Compliance Directive

AGRICULTURAL OPERATION PRACTICES ACT, RSA 2000, c A-7

Directive #: CD 24-09

This directive relates to unauthorized construction of a manure collection area. Ference Land & Cattle Corp (FLCC), which is a beef feedlot confined feeding operation (CFO), has constructed an earthen catch basin without obtaining a permit for the catch basin under the *Agricultural Operation Practices Act (AOPA)*.

A. RA24030 TD 06 Sep 24 Page 6 – additional labelling by Fraser Grant

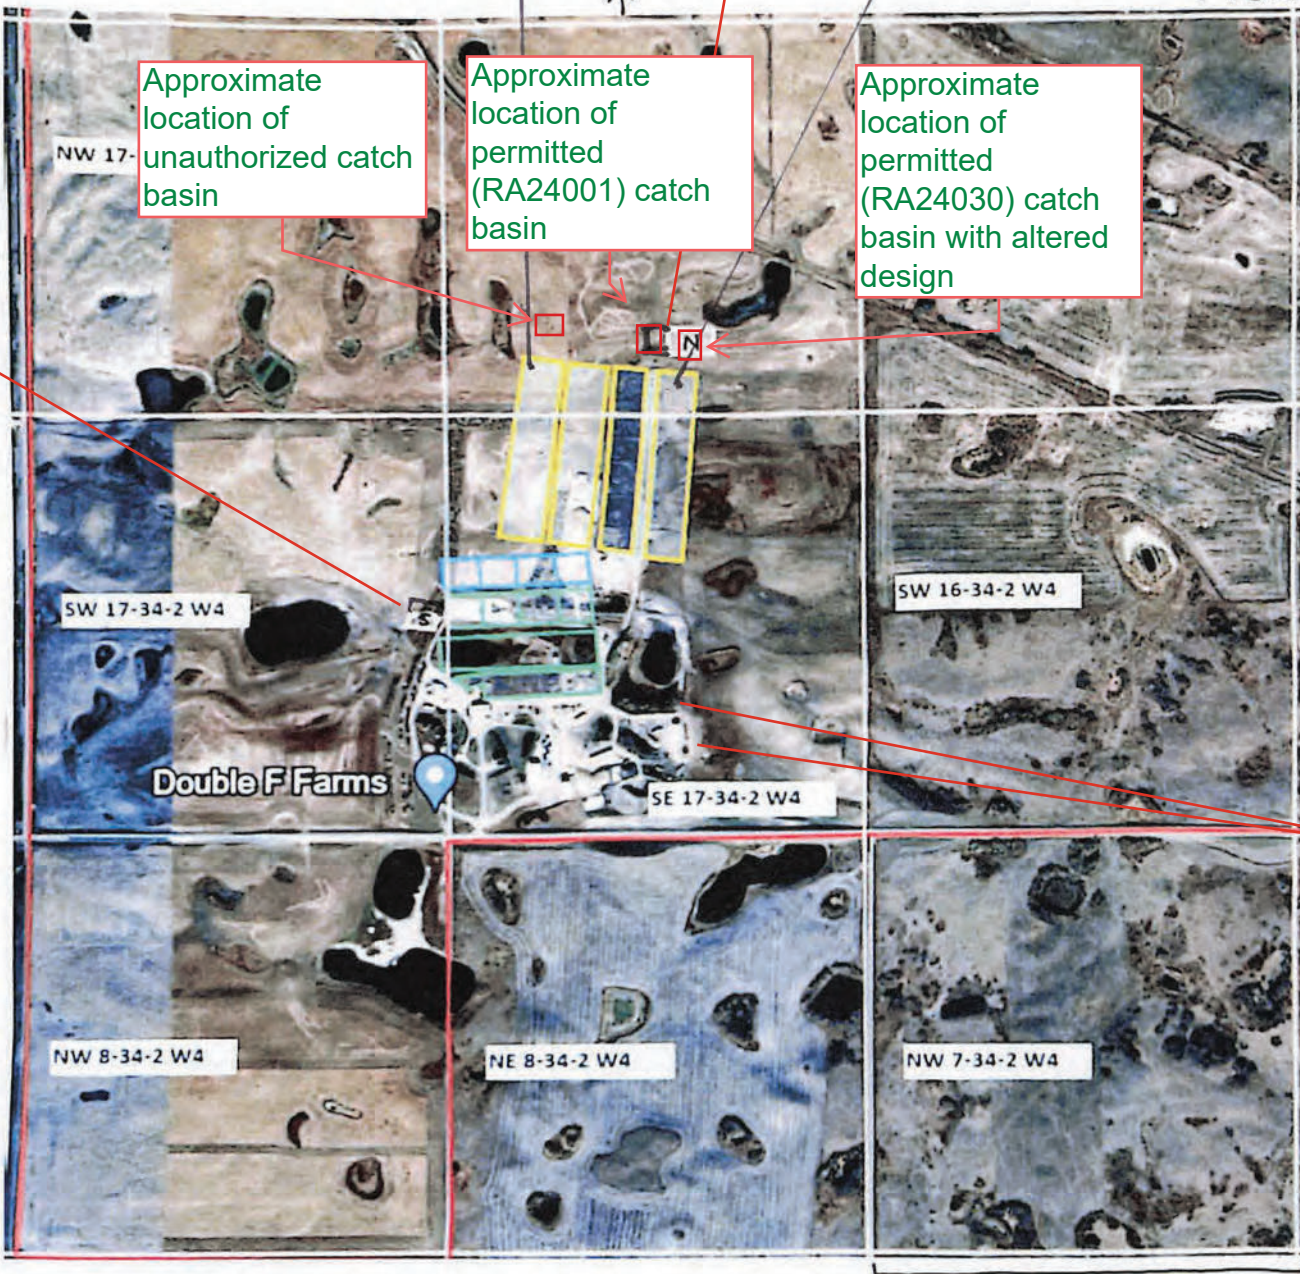
During construction, Mr. Ference determined that this plan was not feasible and that runoff from pens 28-30 would not be able to flow towards the permitted catch basin. As a result, Mr. Ference did not expand the existing northern catch basin. Instead, he constructed two new catch basins. The first one is a smaller catch basin adjacent (to the east) of the existing northern catch basin. This catch basin is within the footprint of

During the inspection, Mr. Ference informed us that the second new catch basin had been constructed to accommodate runoff from pens 28-30, which is located north of this pen row. This new catch basin was not permitted under RA24030, and does not fall within the footprint of facilities permitted under either Approval RA24001 or RA24030. I consider this catch basin as unauthorized construction. According to Mr. Ference, he thought that if the catch basins had enough capacity to accommodate runoff, he could alter the design and location. I informed Mr. Ference that this is not the case and that if he deviates from his NRCB application and approved design, a permit amendment would be required. Mr. Ference was apologetic for the unauthorized construction and immediately contacted his engineer to come to site to collect soil samples from the unauthorized catch basin. Mr. Ference has initiated conversation with Approval Officer Nathan Shirley regarding the submission of an application for an authorization for the unauthorized catch basin.

The unauthorized catch basin measured approximately 20 m x 20 m x 2m. At the time of the post construction inspection, pens 28-30 were not populated and runoff had not entered the unauthorized catch basin. I verbally directed Mr. Ference to not populate pens 28-30 or use the unauthorized catch basin unless an NRCB permit was obtained for the catch basin.

With the information I have and my investigation, I find that the second earthen catch basin (approximately 20m x 20m x 2m) has been constructed in contravention of section 14.

1. Not populate pens 28-30 until:
 - a. an NRCB permit, new or amended, has been issued for the unauthorized catch basin; and
 - b. an NRCB post construction inspection has been completed for the unauthorized catch basin and you have received confirmation, in writing, from the NRCB that confirms the catch basin has been completed as proposed.
2. Ensure that their next permit application to the NRCB reflects the changes to the catch basin permitted under RA24030 (the NE catch basin).
